KBSO Project #: 24023
Project Name: Noblesville HS AHU Replacements – Bid Pack 2
Issue Date: 10/10/2024

This Addendum number 1 to the drawings and specifications shall supplement, amend, and become a part of the bidding documents, plans, and specifications. All bids and construction contracts shall be based on these modifications to the original contract documents.

MECH RM M12
MECHANICAL
DEMOLITION
PLAN

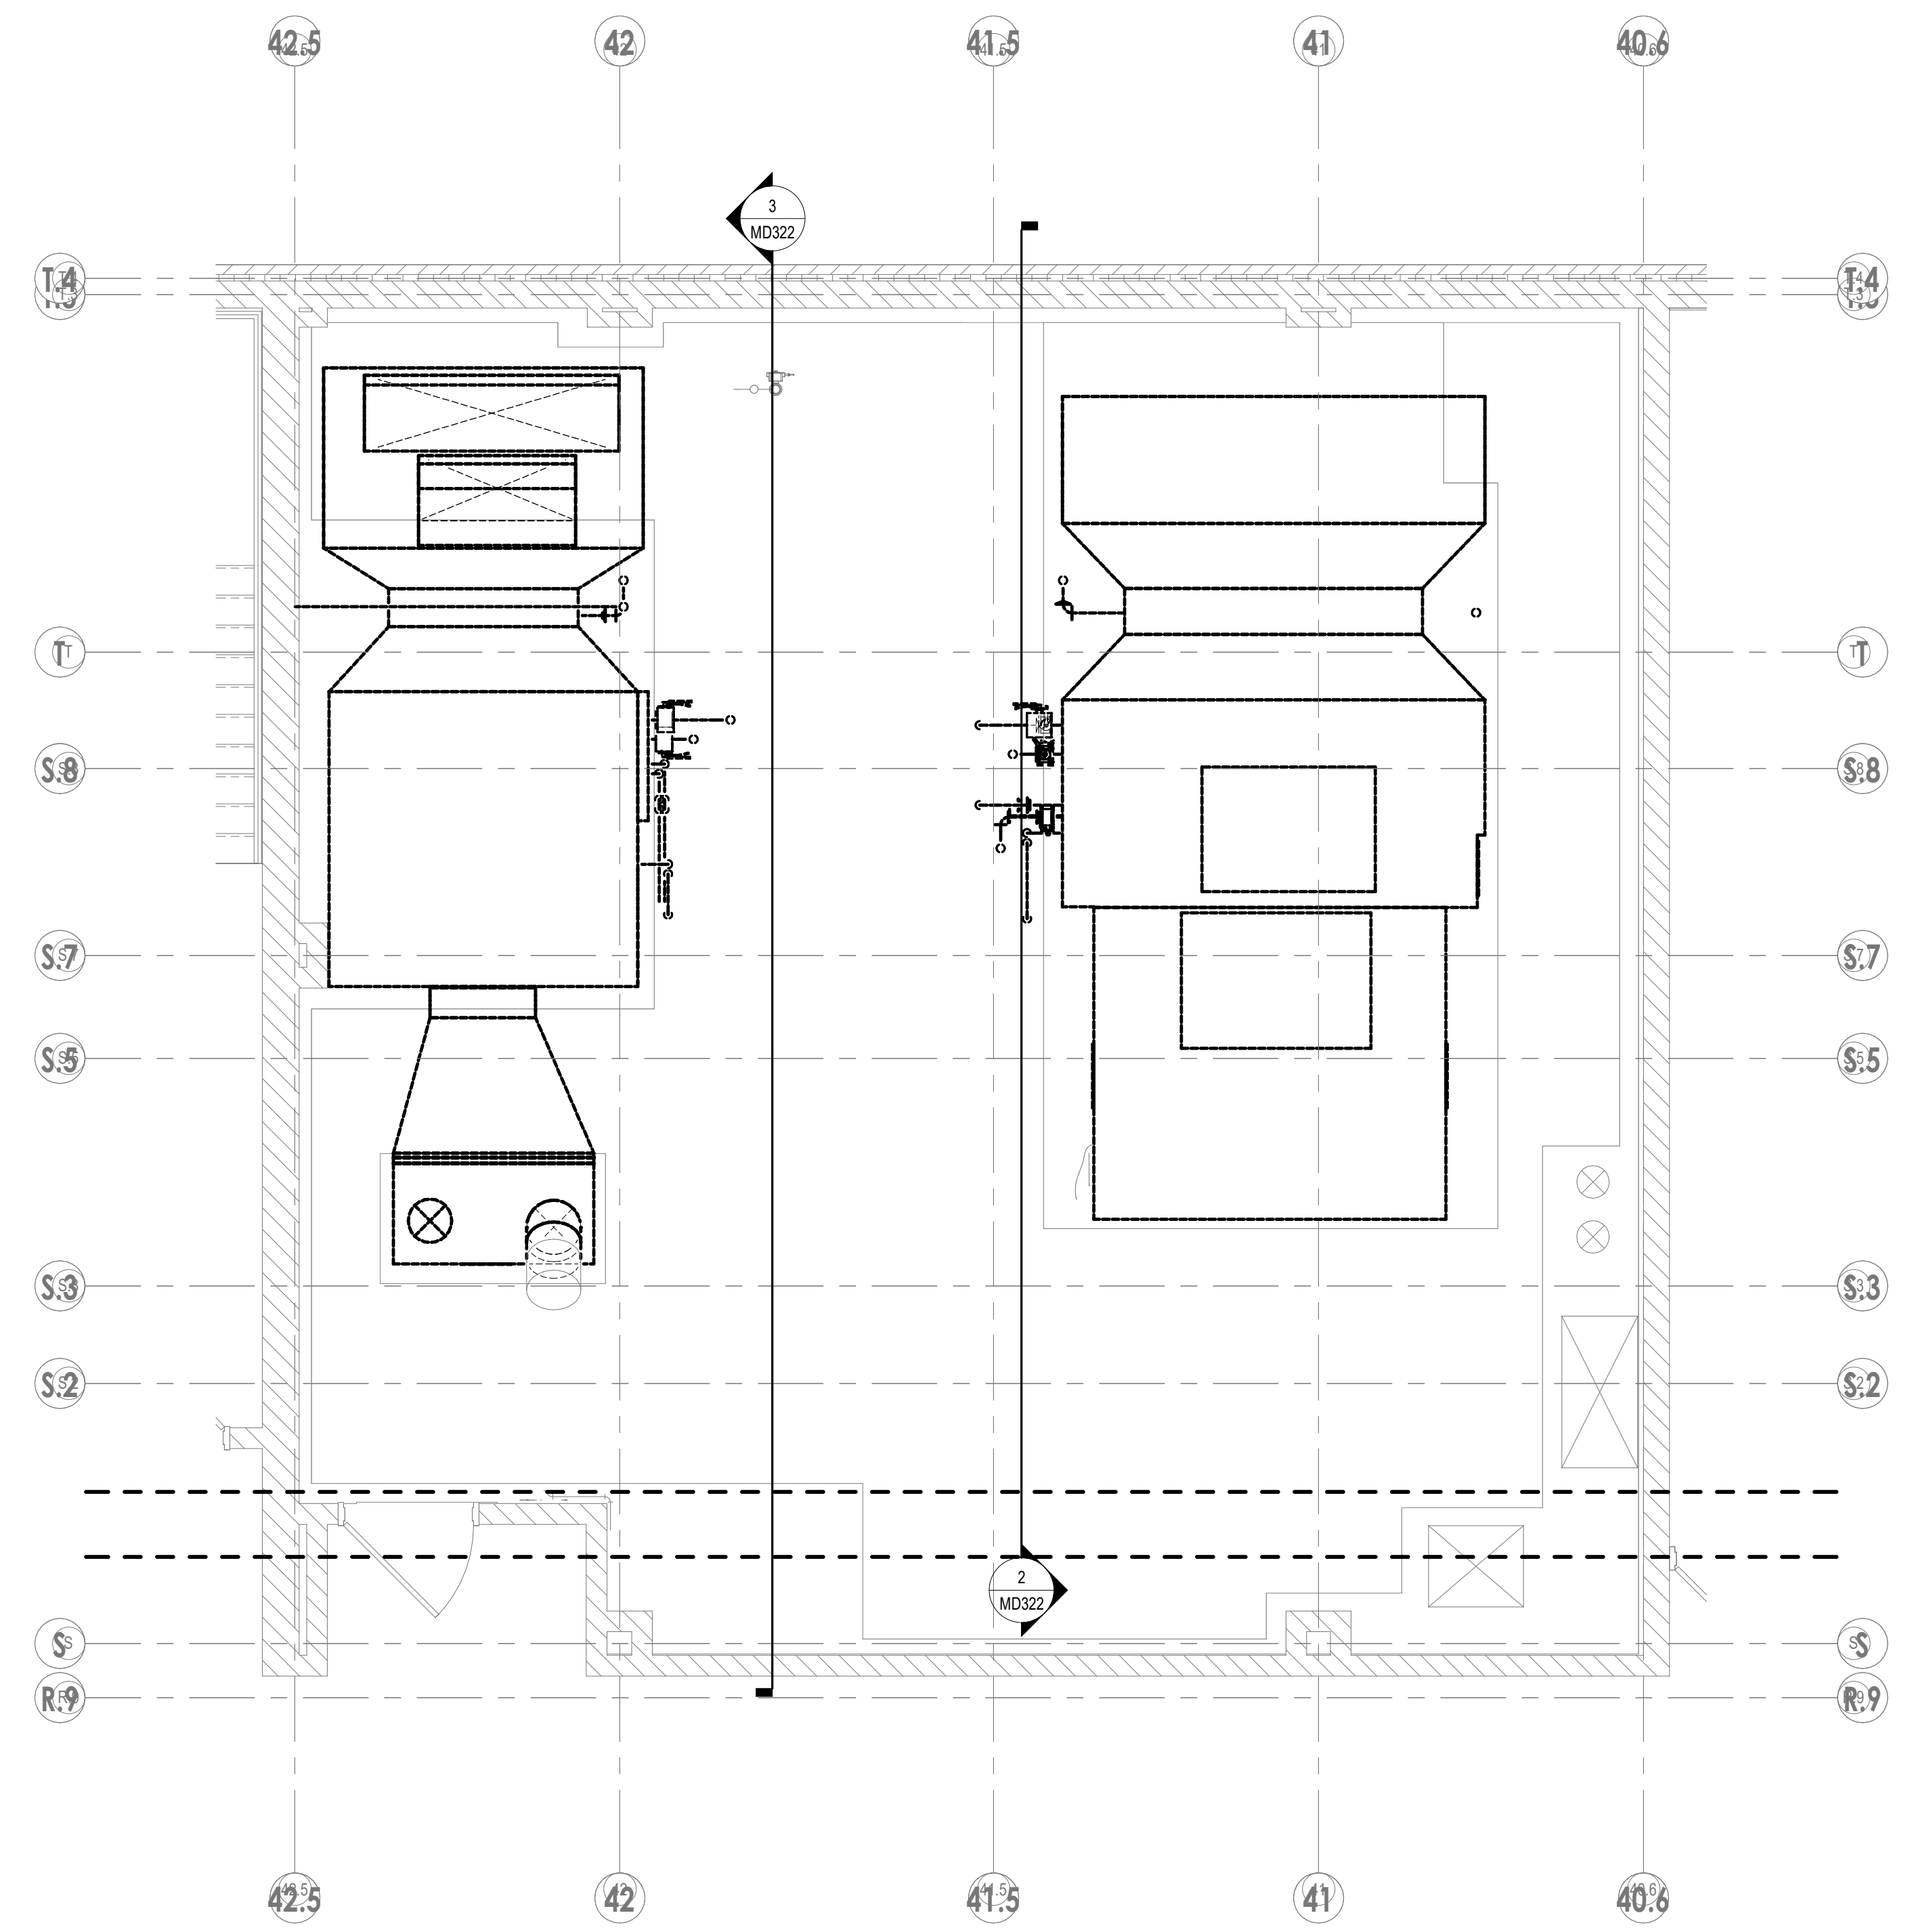
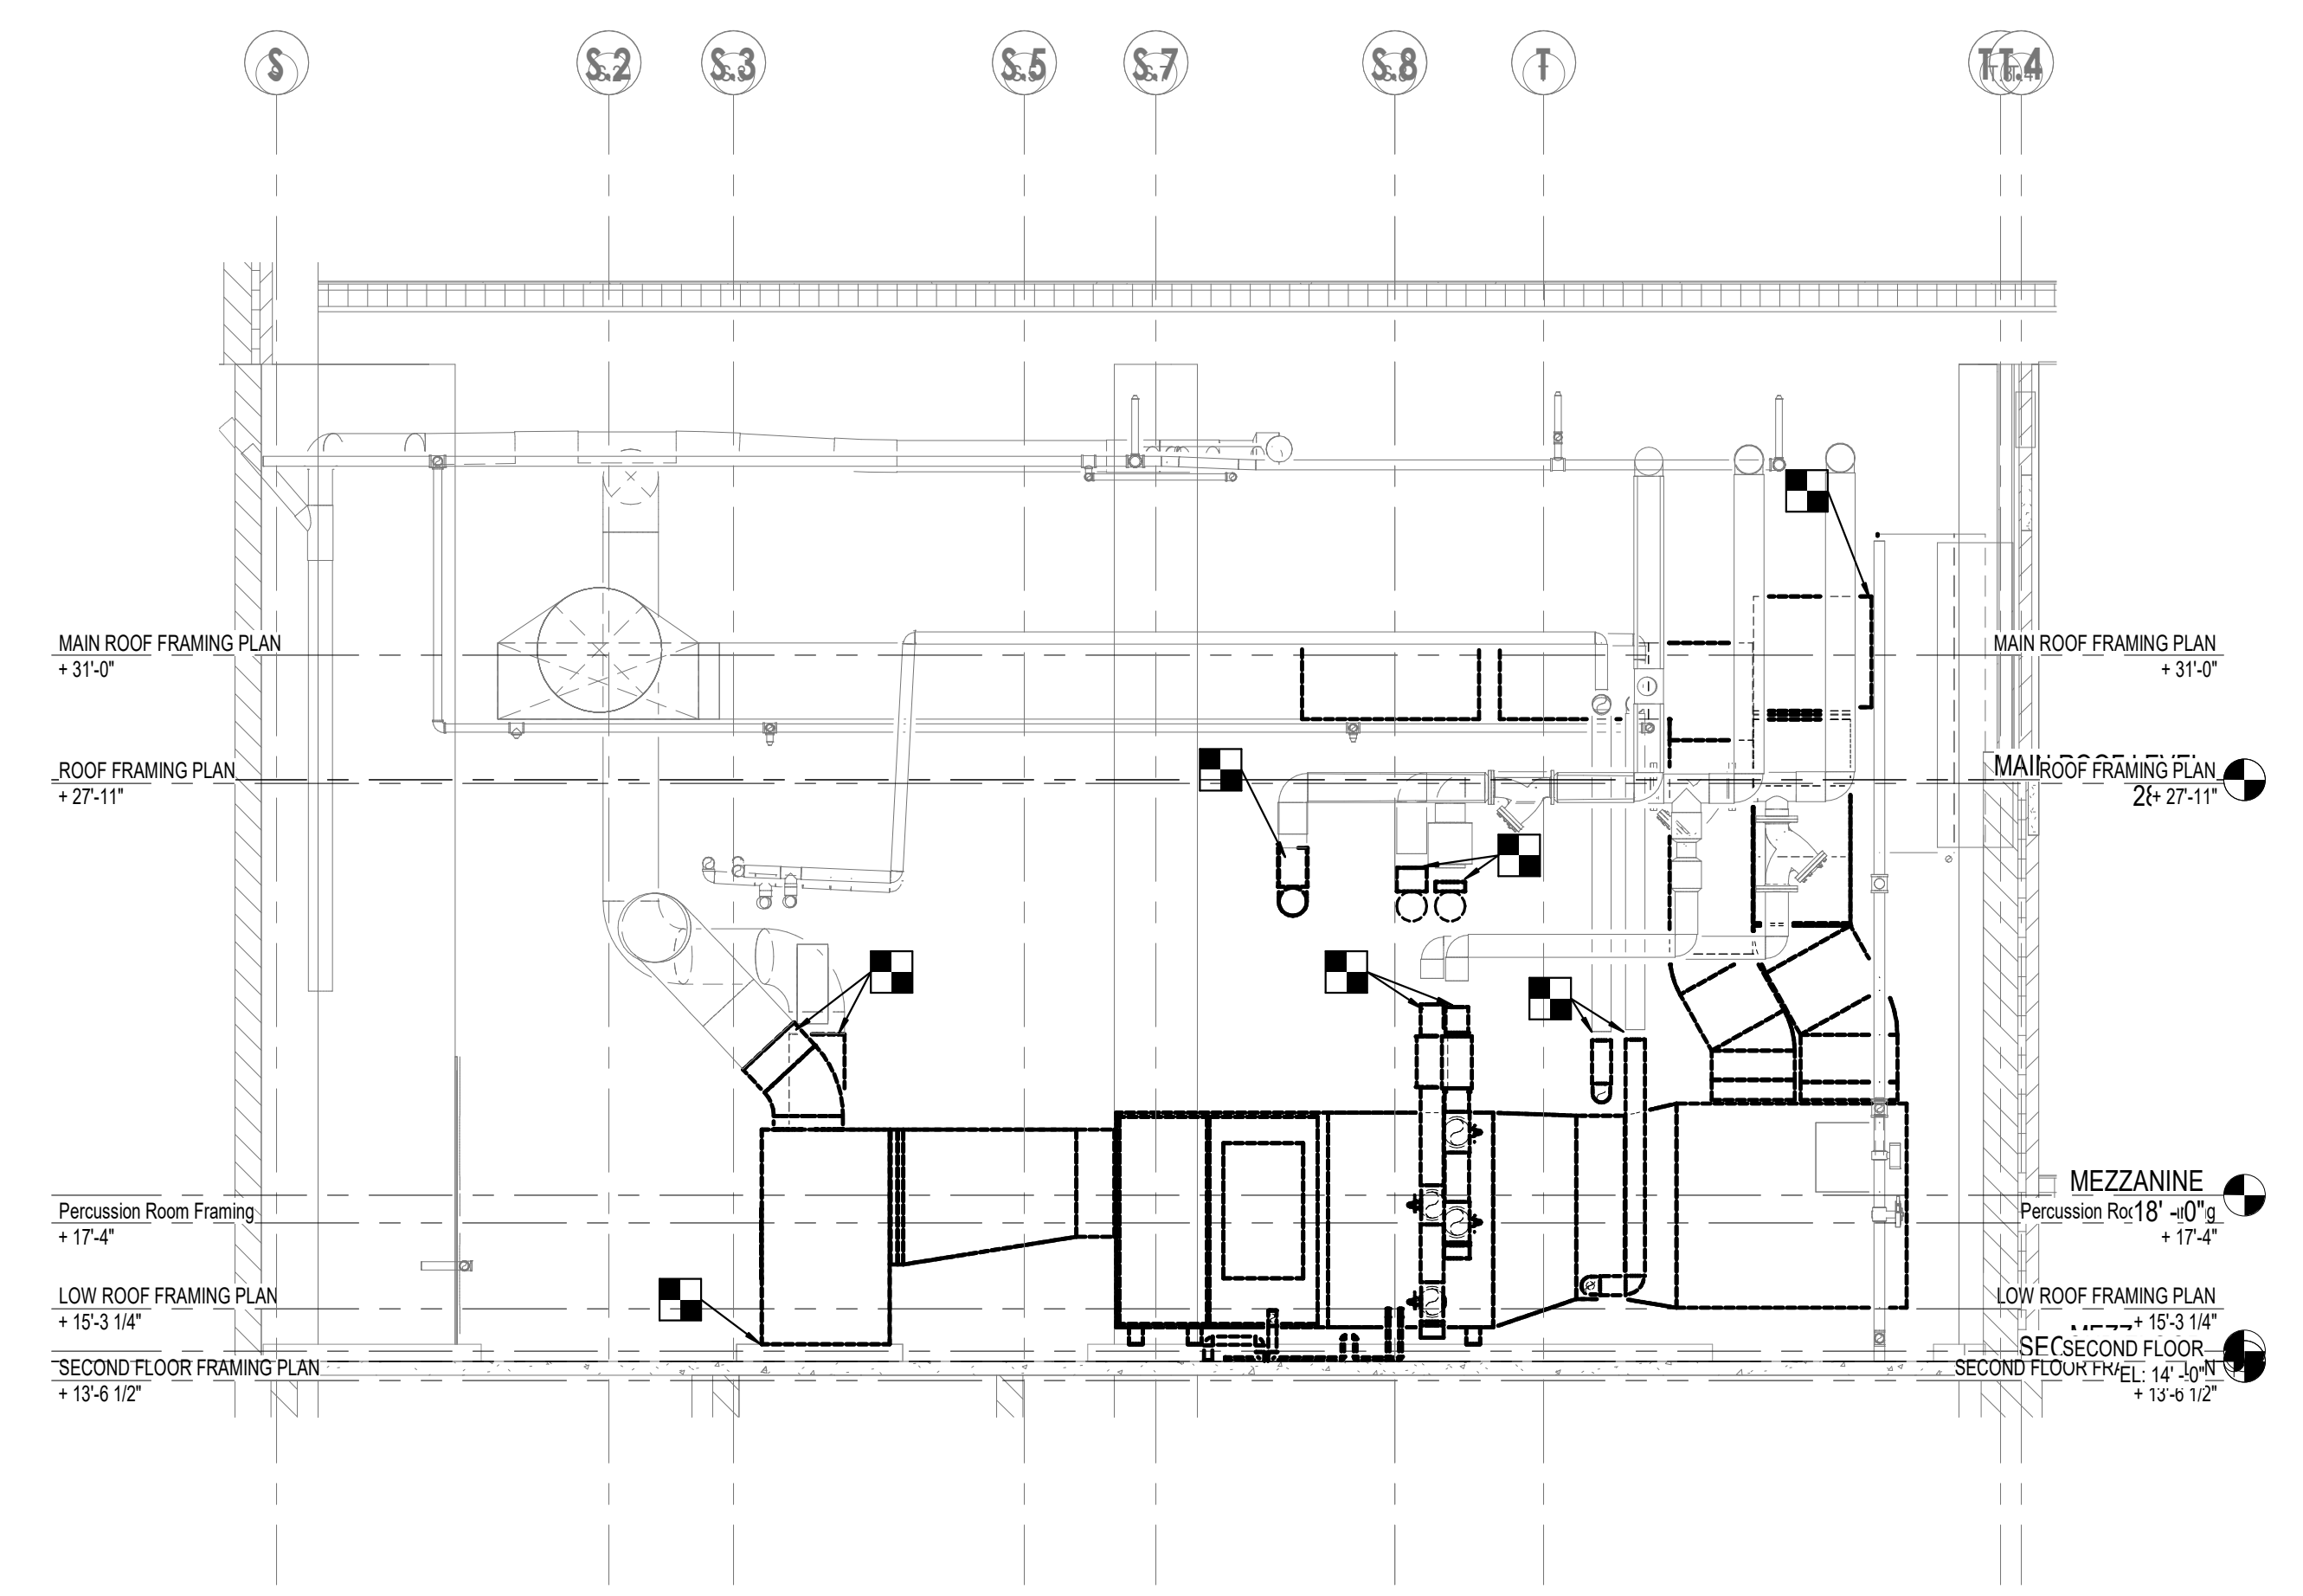
- 3.01 M521 - MECHANICAL DETAILS
 - a. See revised drawings with revision clouds included
- 3.02 M621 - MECHANICAL SCHEDULES
 - a. See revised drawings with revision clouds included
- 3.03 M721 - GROUND FLOOR CONTROLS & LOGISTICS PLAN
 - a. See revised drawings with revision clouds included
- 3.04 M722 - SECOND FLOOR CONTROLS & LOGISTICS PLAN
 - a. See revised drawings with revision clouds included
- 3.05 MD321 - MECH RM M11 MECHANICAL DEMOLITION PLAN
 - a. See revised drawings with revision clouds included
- 3.06 MD322 - MECH RM M12 MECHANICAL DEMOLITION PLAN
 - a. See revised drawings with revision clouds included
